Service Bulletin

Bulletin No.: 22-NA-067

Subject: Poor Engine Performance in Extremely Cold Weather Conditions, PCV Bypass Hose and Charge Air Cooler Icing for LUV Engines, Malfunction Indicator Lamp (MIL) Illuminated - DTC P0299, P0234, P0236, P2261, P2227, P00C7 Set

5286457

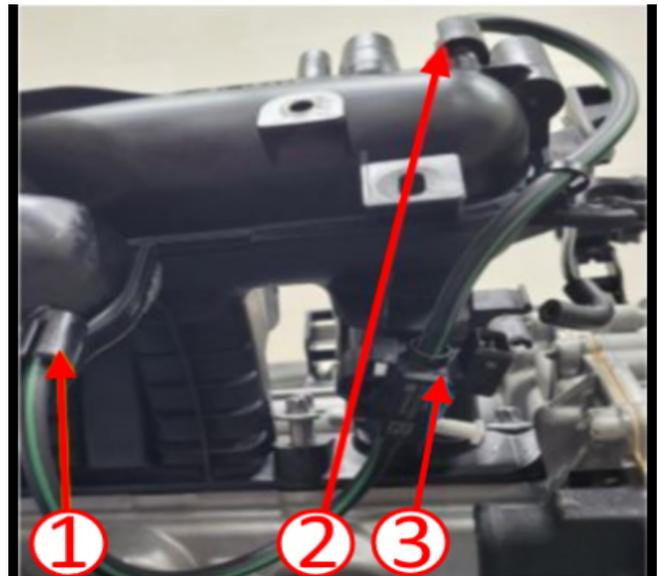
- 4. Inspect the PCV intake runner for ice build-up blocking the cylinder head as shown above.

- 5. Clean any ice/sludge/water/carbon out of the cylinder head, cam cover and PCV pipes. If above condition exists, then replace the intake manifold. Refer to *Intake Manifold Replacement* in SI.

Intake Manifold Redesign Inspection and Familiarization

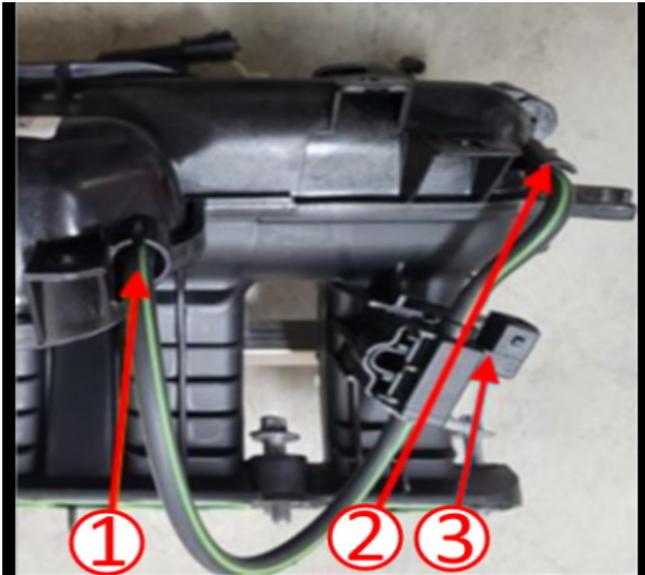
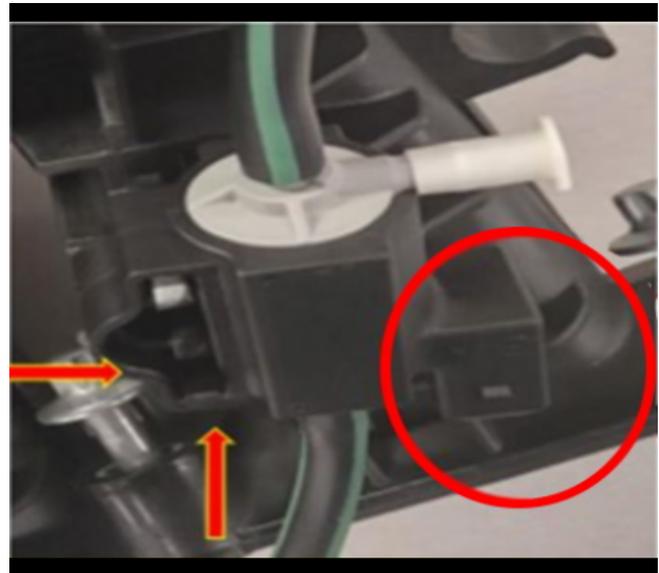
New intake manifold with a re-designed intake positive pressure port location. Solenoid location is electrical connector forward. The vacuum feed is in the same location. If the solenoid is found to be loose, review the location of the electrical connector. If the connector is facing the head of the assembly, it is installed backwards and will need to be removed and installed correctly.

Note: The electrical receptacle location. Remove and re-install the lines and solenoid as they are retained to the intake if installed incorrectly. Tabs reversed, the solenoid is keyed and will not be seated in retainers.
